# GRANDVIEW RESERVE METROPOLITAN DISTRICT INTERCEPTOR SEWER CONSTRUCTION DOCUMENTS

## AND EROSION CONTROL PLANS COUNTY OF EL PASO, STATE OF COLORADO

CONSTRUCTION DOCUMENTS  
COVER SHEET

SHEET  
**C100**

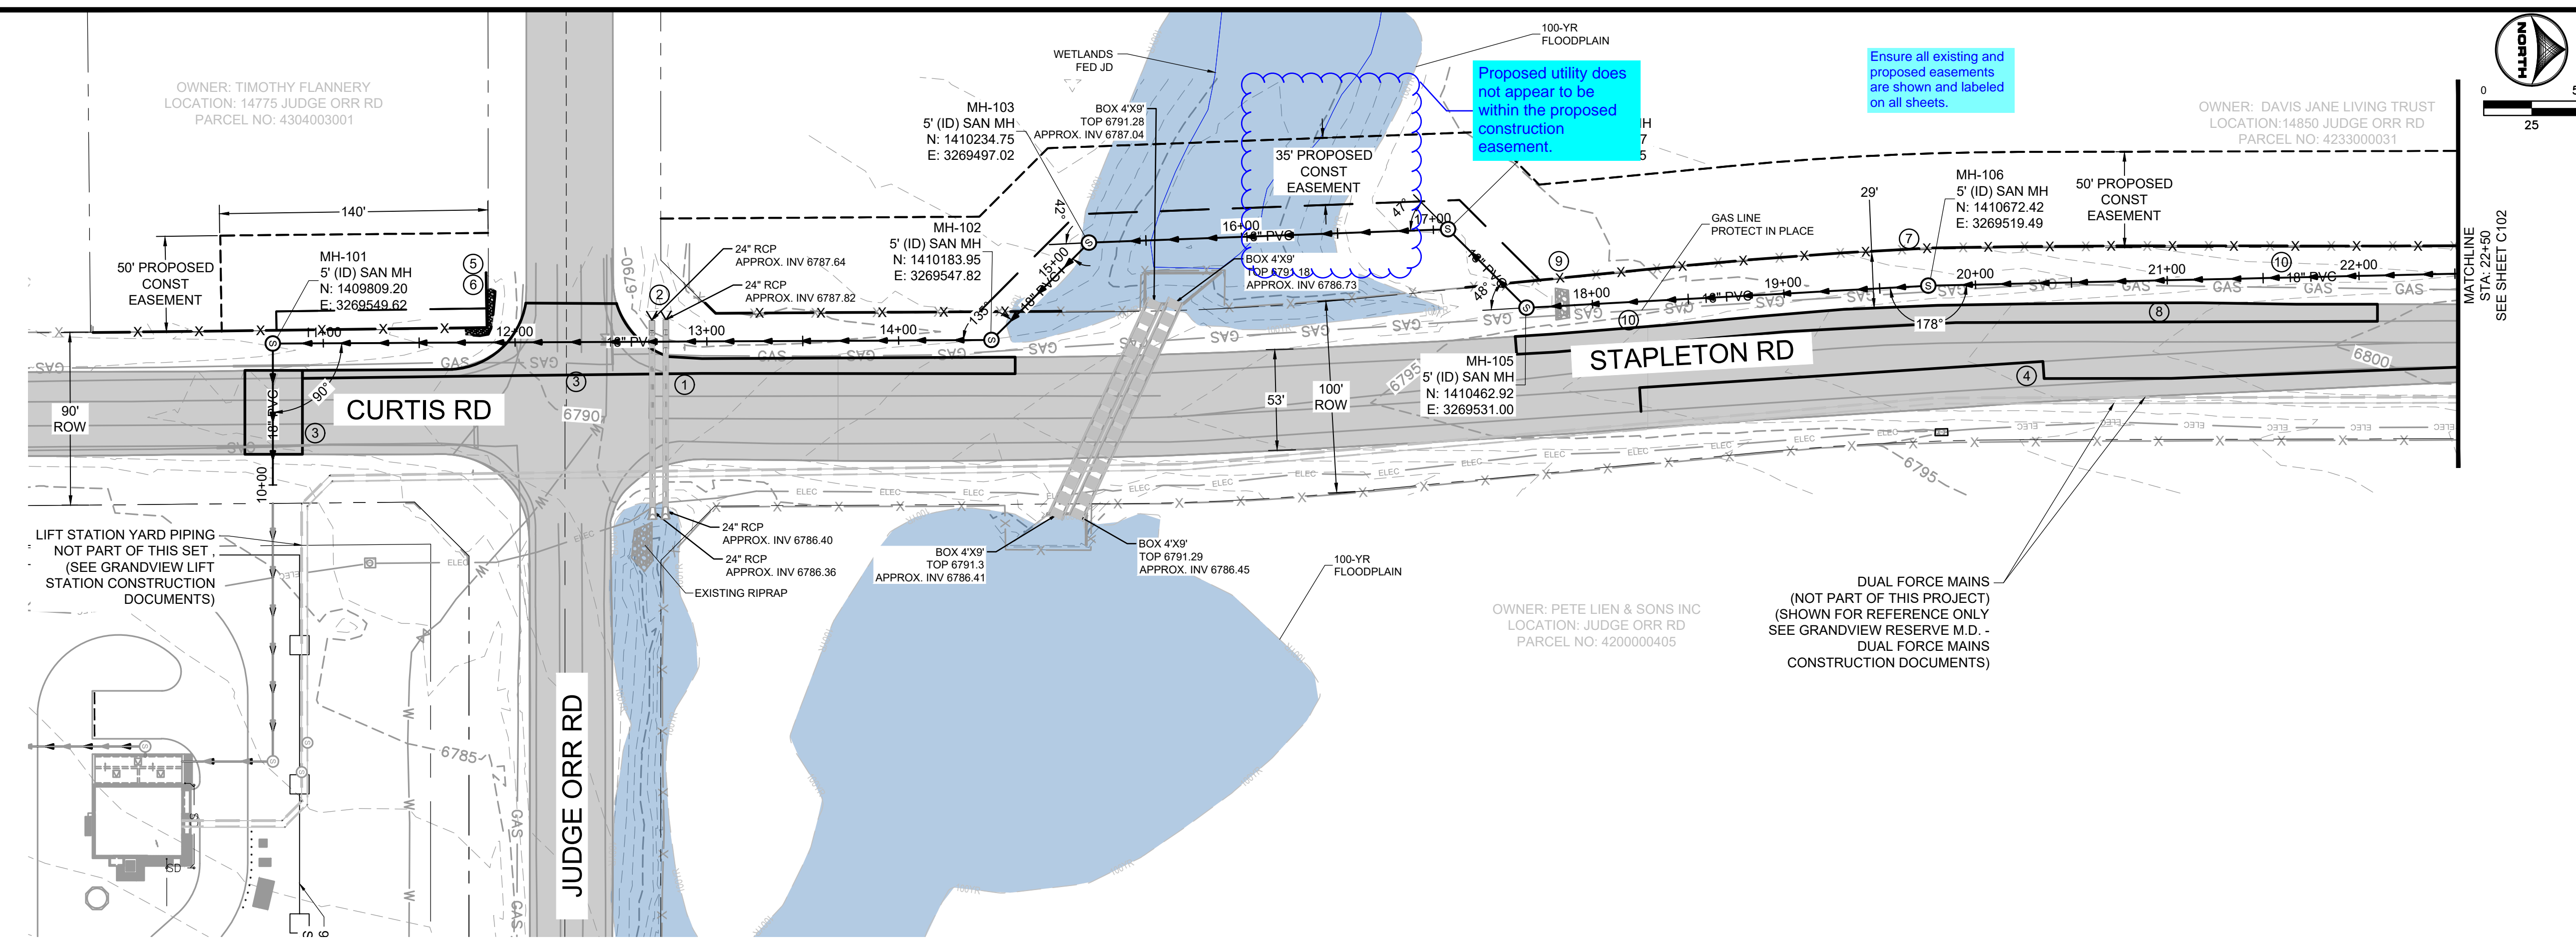
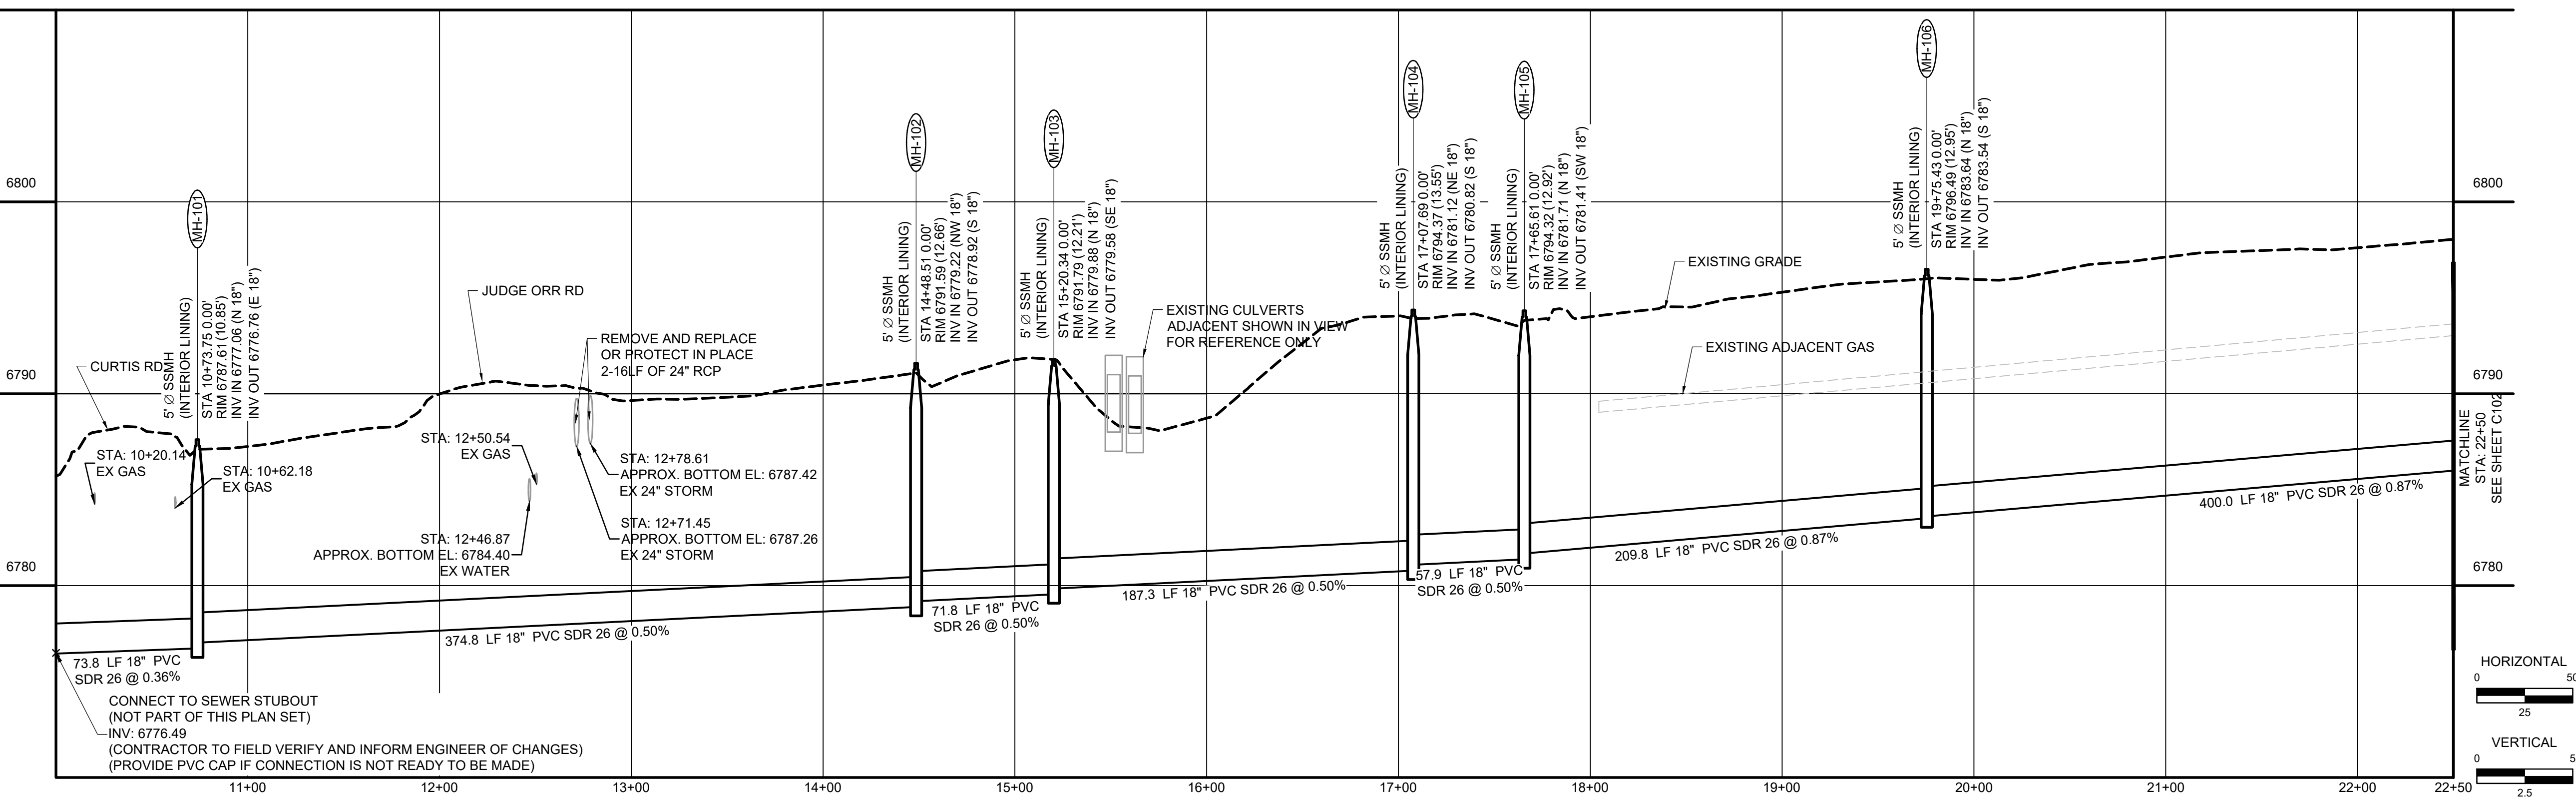
- KEY NOTES:** Shown as 24" on plans
- PROTECT IN PLACE OR REMOVE AND REINSTALL STORM SEWER. EXISTING PIPES ARE ELLIPTICAL PIPE 3' WIDE AND 2' TALL.
  - PROTECT IN PLACE OR REMOVE AND REINSTALL FLARED ENDS.
  - REMOVE AND REPLACE ASPHALT PAVEMENT, AND WHITE AND YELLOW PAVEMENT MARKINGS.
  - REMOVALS FOR FORCE MAIN INSTALLATION (NOT PART OF THIS PROJECT).
  - PROTECT IN PLACE OR REMOVE AND REINSTALL BARBED WIRE FENCING AND WOOD POSTS.
  - PROTECT IN PLACE OR REMOVE AND REINSTALL STONES.
  - PROTECT IN PLACE OR REMOVE AND REINSTALL BARBED WIRE FENCING AND STEEL POSTS.
  - REMOVE AND REPLACE ASPHALT PAVEMENT.
  - PROTECT IN PLACE OR REMOVE AND REINSTALL RIP RAP.
  - GAS LINE, PROTECT IN PLACE.

SHEET  
**C102**

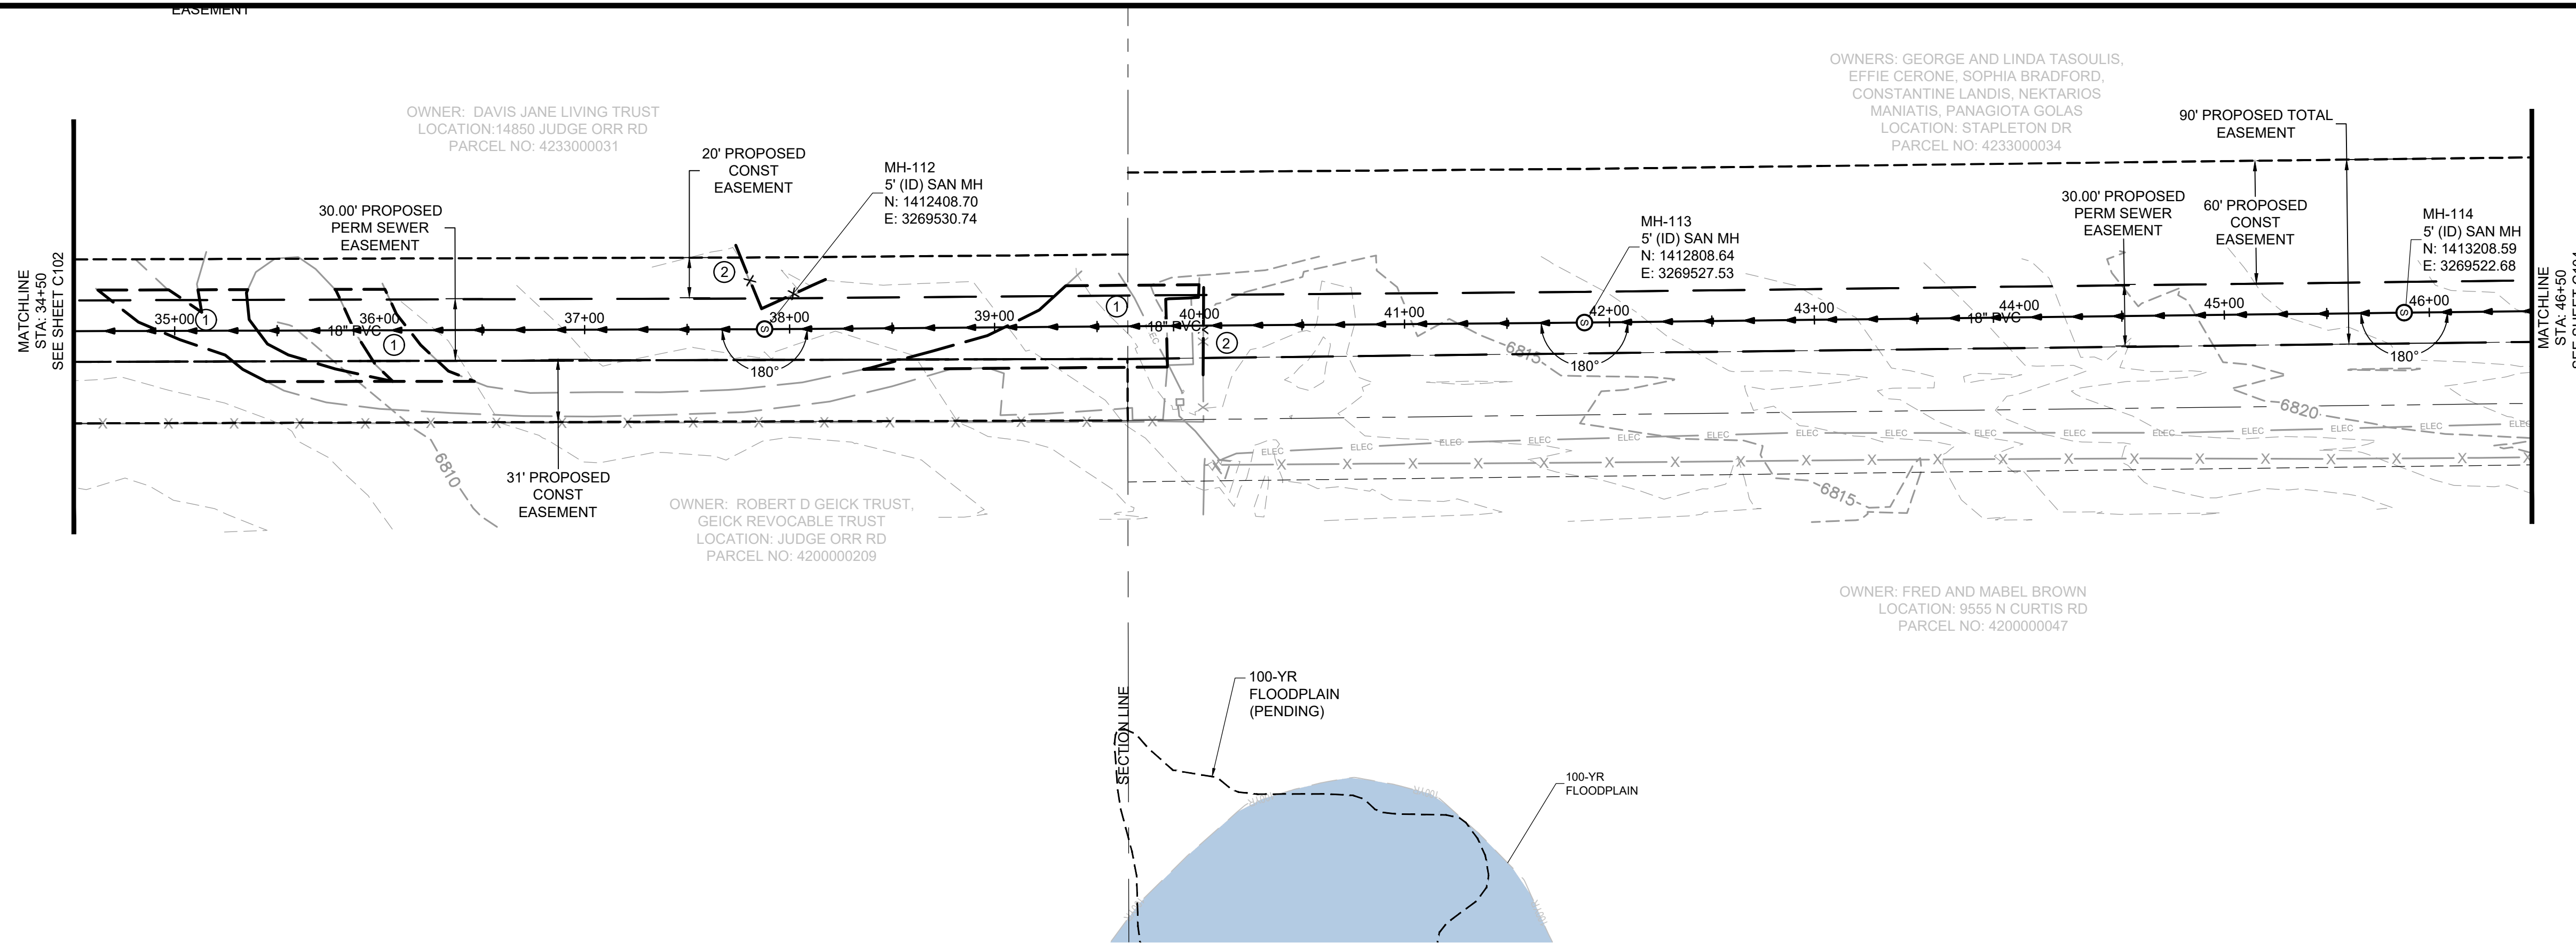
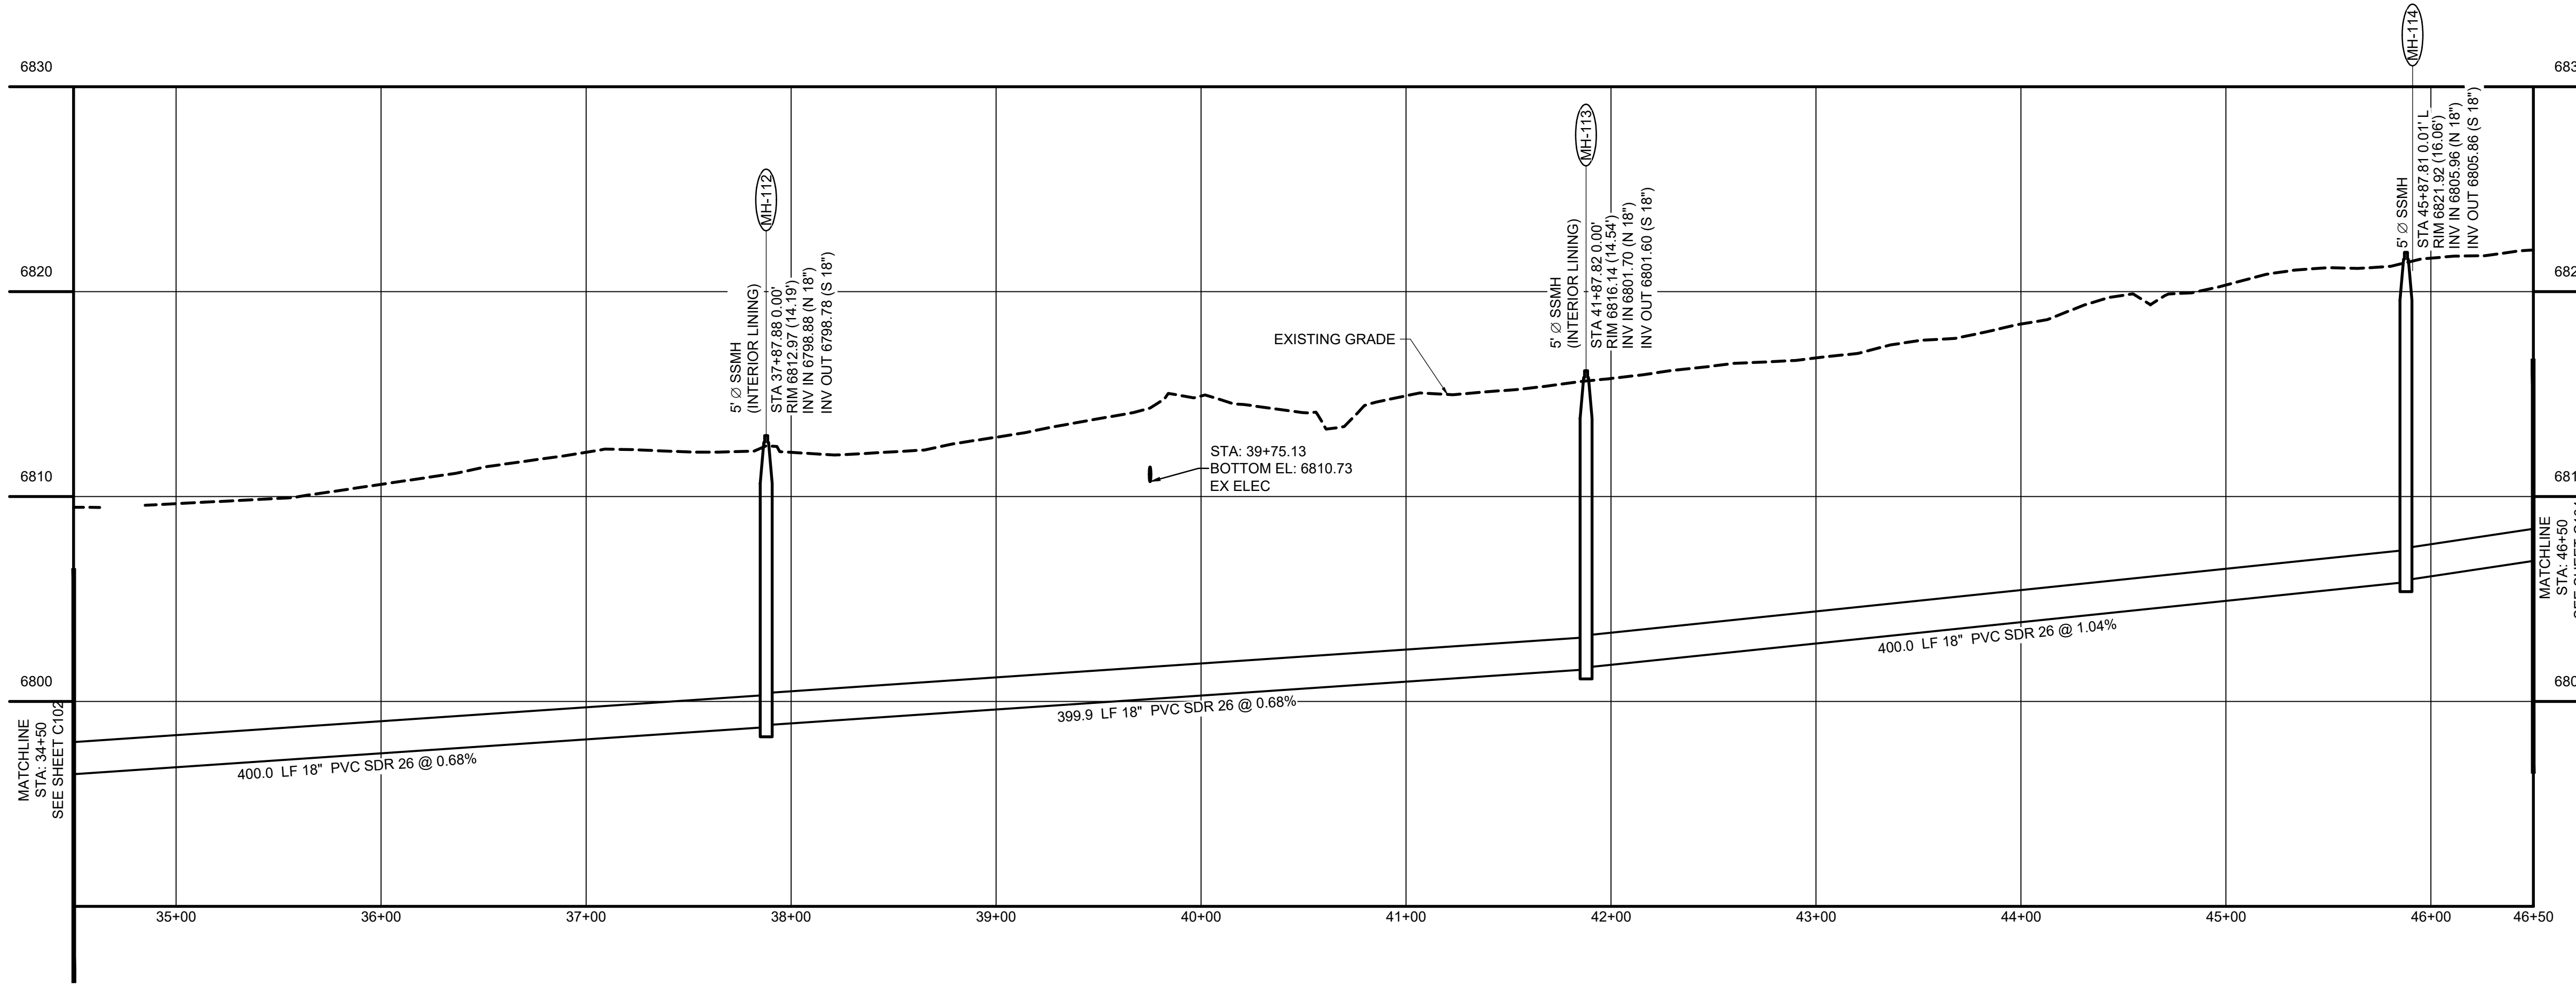
**Subject:** Callout  
**Page Label:** [8] C102 GRAVITY LINE PLAN AND PROFILE Label  
**Author:** CDurham  
**Date:** 7/29/2024 5:25:36 PM  
**Status:**  
**Color:** ■  
**Layer:**  
**Space:**
